ADDENDUM NUMBER TWO

PROJECT:
RE-ROOF HANGAR ROW 3001
3001 AIRPARK DRIVE
SANTA MARIA PUBLIC AIRPORT
SANTA MARIA CA 93455

**REVISED DETAIL 3 ON
SHEET A-1, ADDENDUM 2,
4/1/2023**

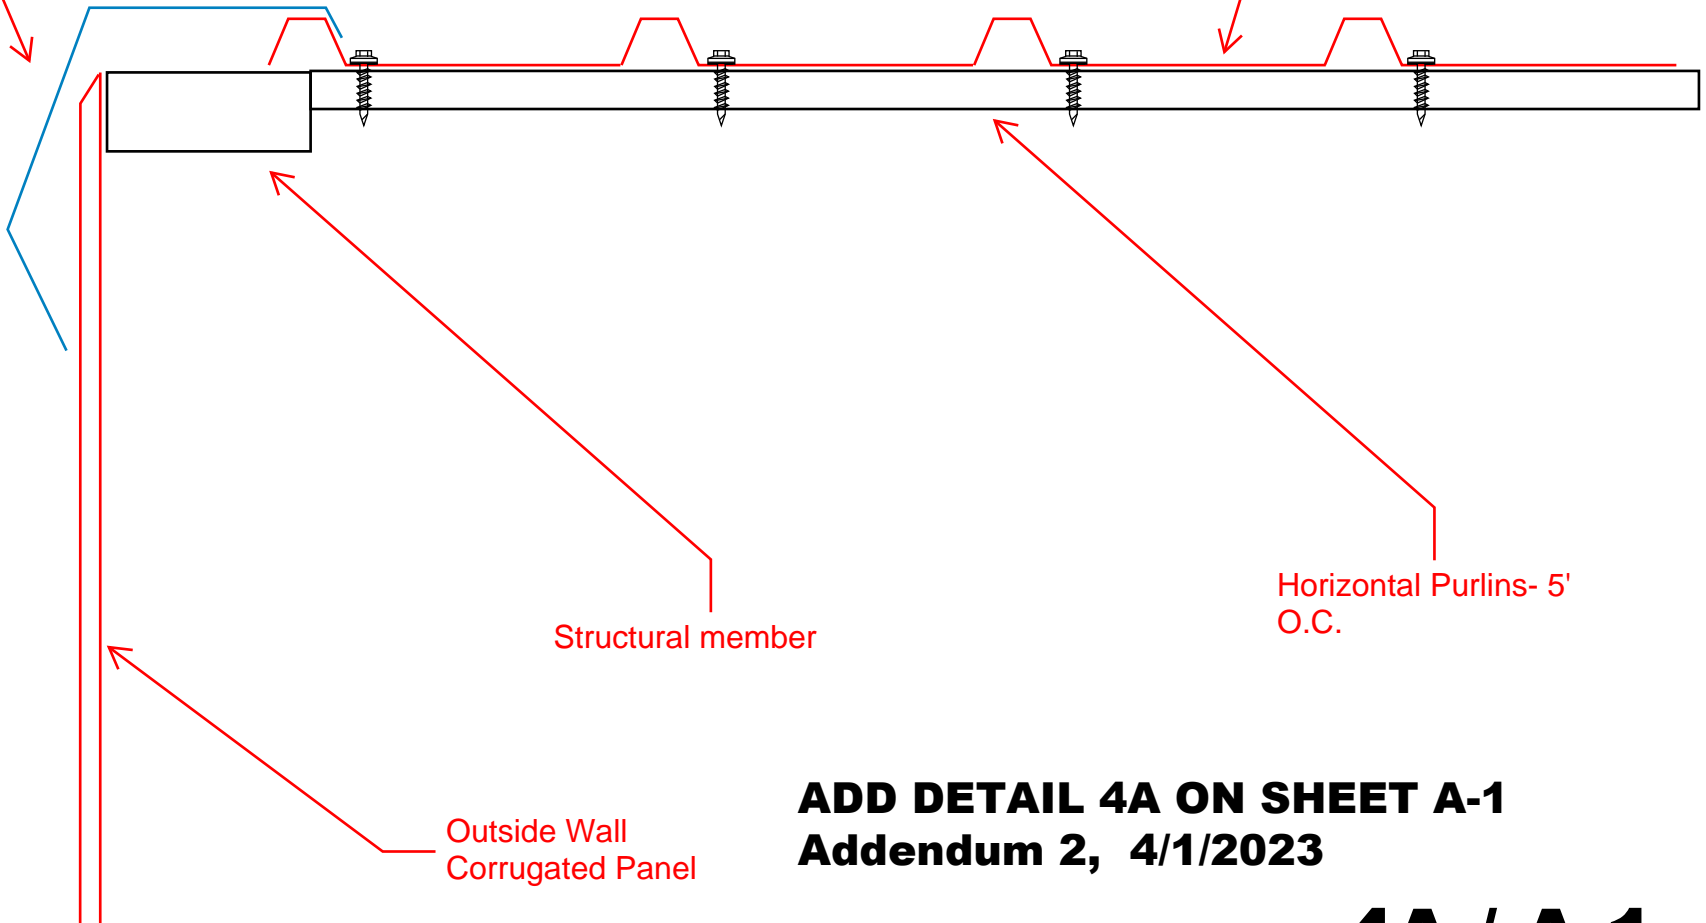
Item No. 1: Sheet A-1, revised section detail 3.

REVISED DETAIL 3 ON SHEET A-1

PVC membrane-
mechanically attached to
Purlins with Rhinobond
plates

**ADD DETAIL 4A ON SHEET A-1
Addendum 2, 4/1/2023**

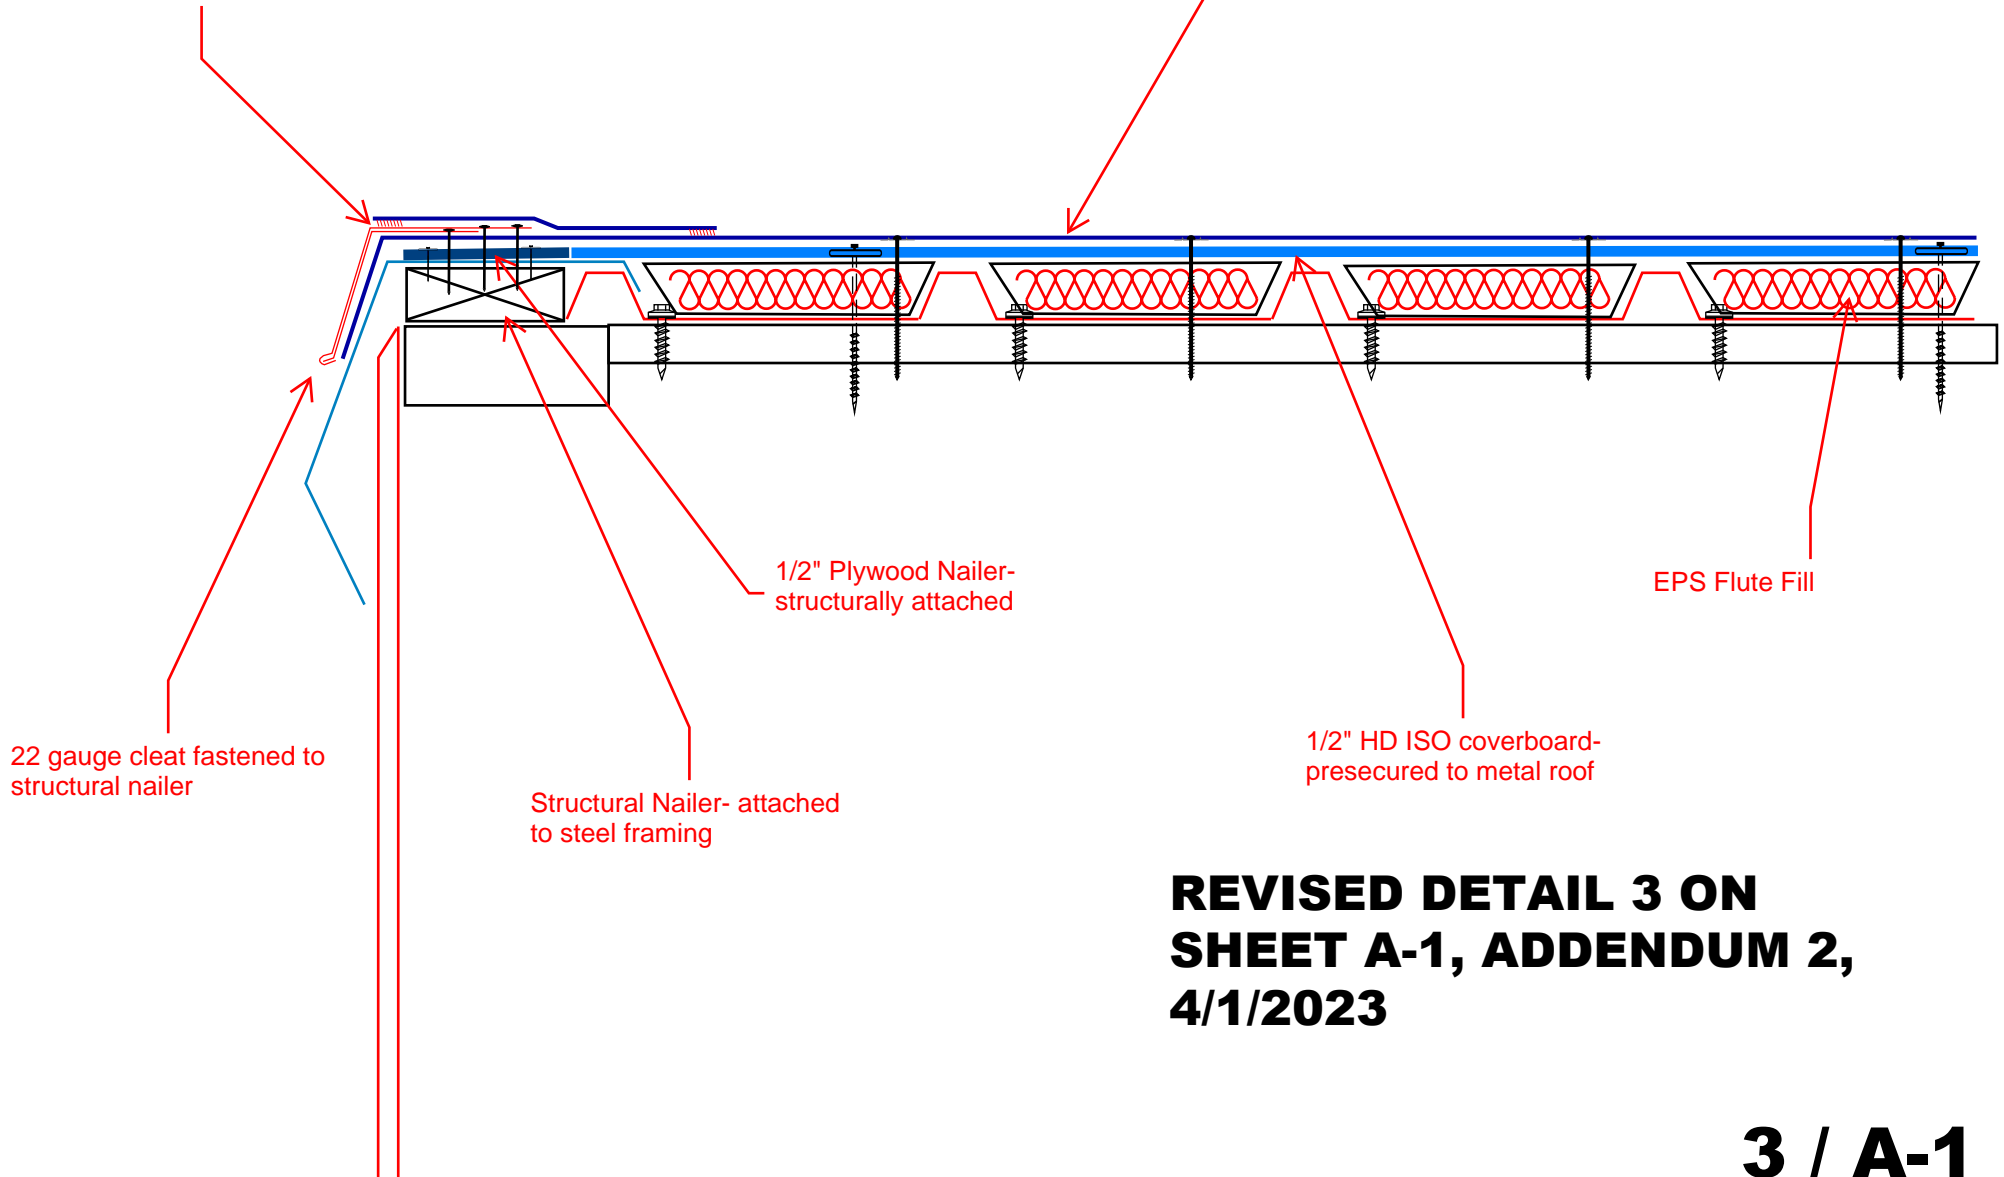
Item No. 2: Sheet A-1, added detail 4A.

24 gauge Sarnaclad-
Typical Edge Metal Detail
